PROPOSED CHANGE TO THE OPERATING LICENSE

REMOVAL OF CYCLE SPECIFIC PARAMETERS FROM TECHNICAL SPECIFICATIONS

(GGNS PCOL-92/07)

GGNS PCOL-92/07 - MARKED-UP TECHNICAL SPECIFICATION PAGES

FIGURE 3.2.4-2 LHGRFAC₁

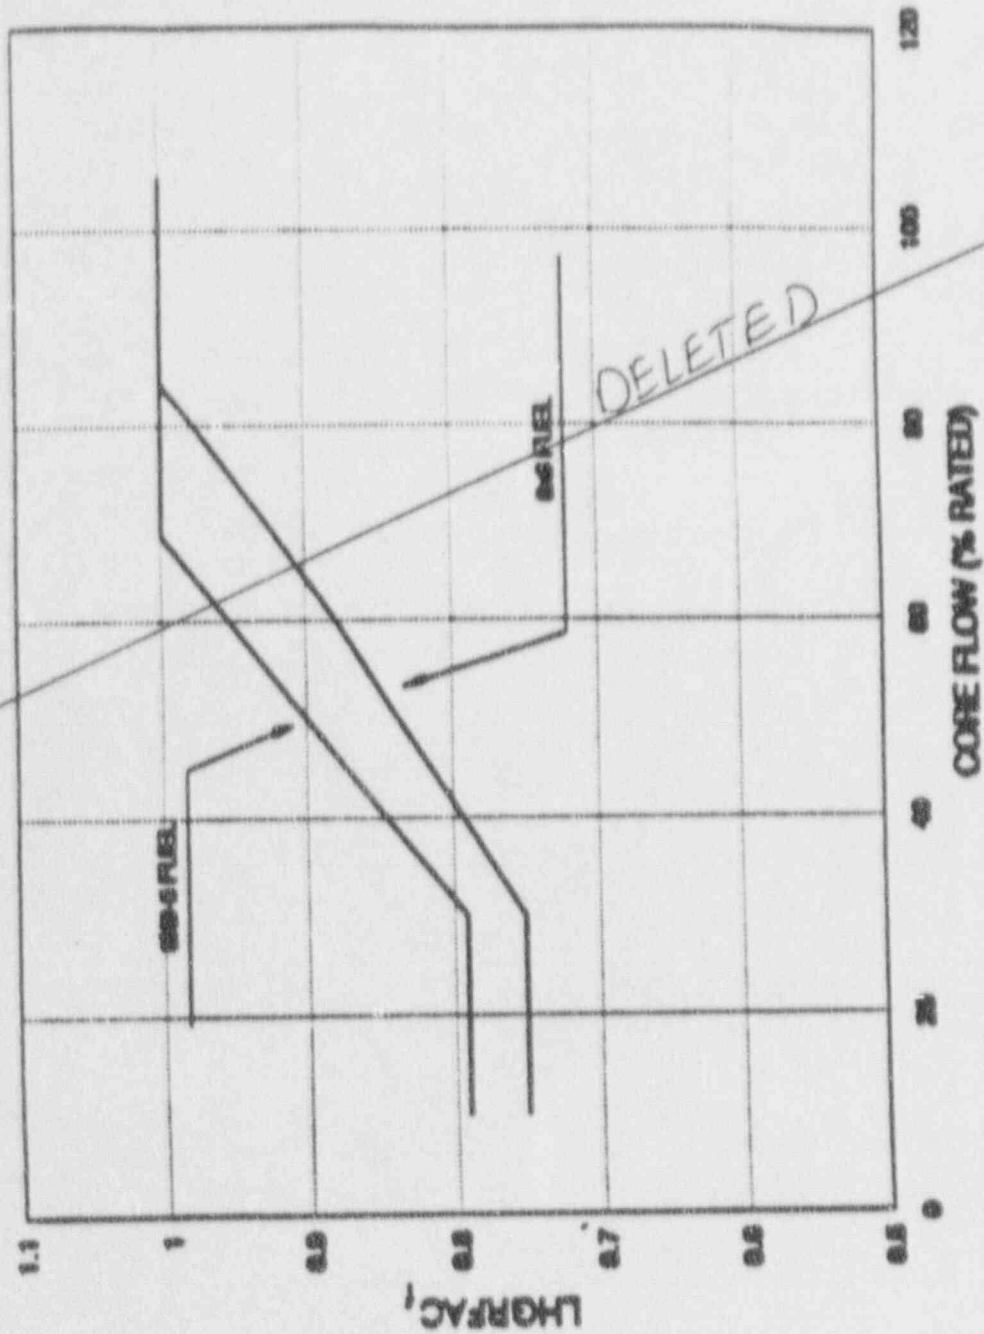
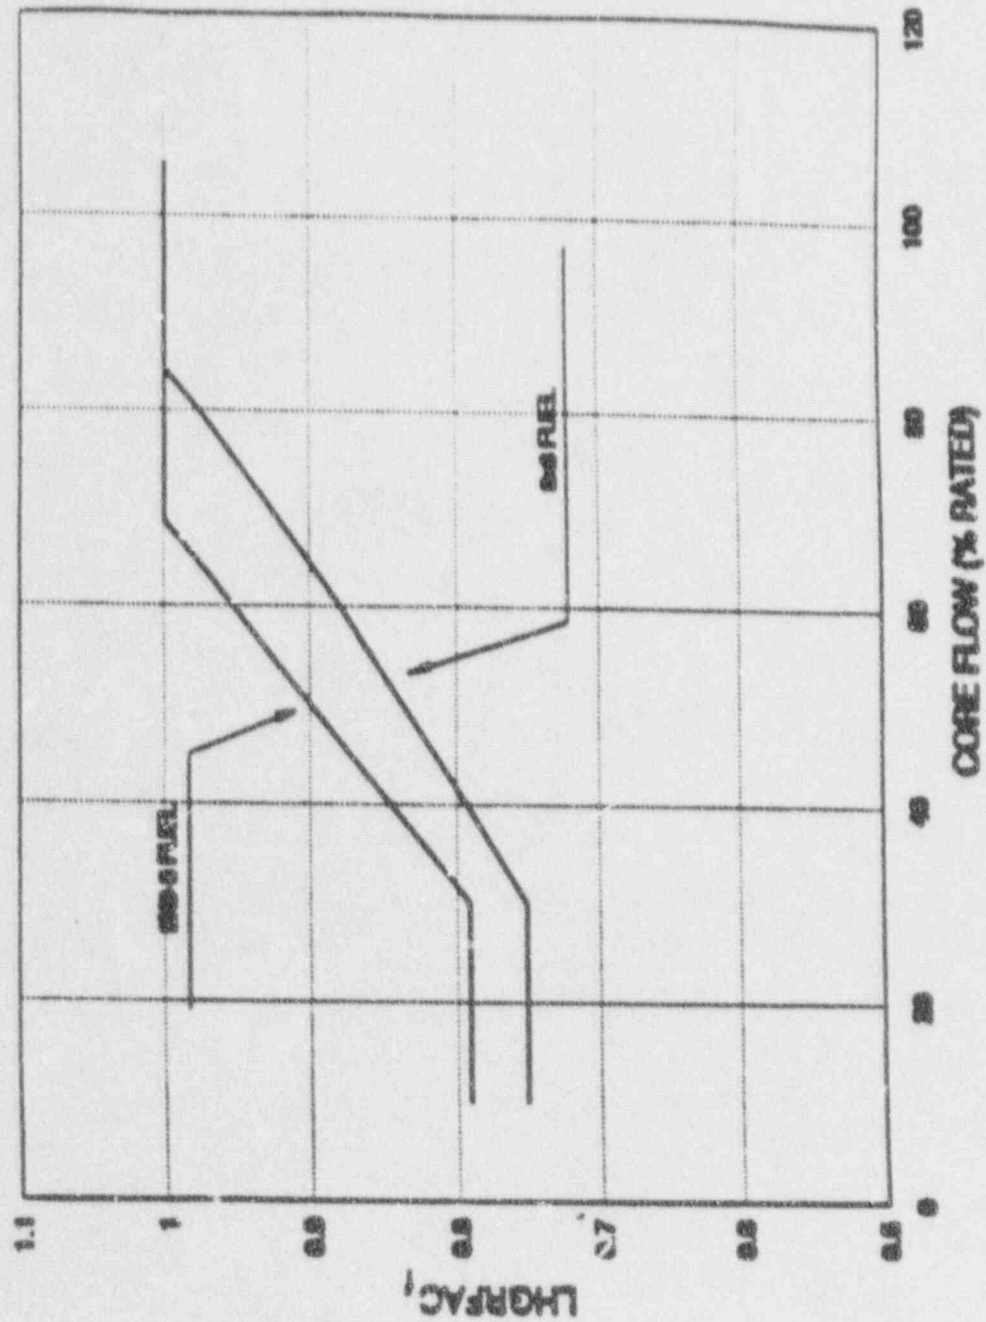
3.2.4 The LINEAR HEAT GENERATION RATE (LHGR) shall not exceed the limits specified in Figure 3.2.4-1 as multiplied by the smaller of either the flow-dependent LHGR factor (LHGRFAC_f) of Figure 3.2.4-2, or the power-dependent LHGR factor (LHGRFAC_p) of Figure 3.2.4-3, specified in the CORE OPERATING LIMITS REPORT. DELETE
